J2 TECHNICAL ARTICLE

Number 75

SERVICE INFORMATION SHEET NO. 37 - BRAKE CABLES

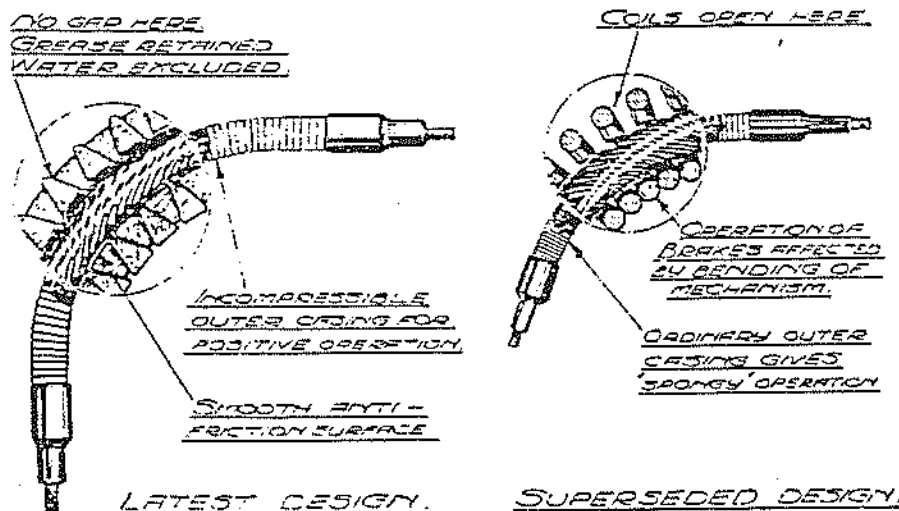
Our brake cable suppliers inform us that they have patented a new improved type of brake cable to supersede previous types.

The new type of cable, which is marketed under the trade name of "Bowdenex T," is fitted with an outer casing which is designed to retain the same mean length whether bent or straight, and is, at the same time, incompressible. The sketch below illustrates this point.

It is a matter of considerable importance to ensure that the new cables are fitted in pairs per axle, as one of the new type fitted in conjunction with one of the old type will inevitably result in uneven braking.

LUBRICATION: A lubricant having a graphite content must be used.
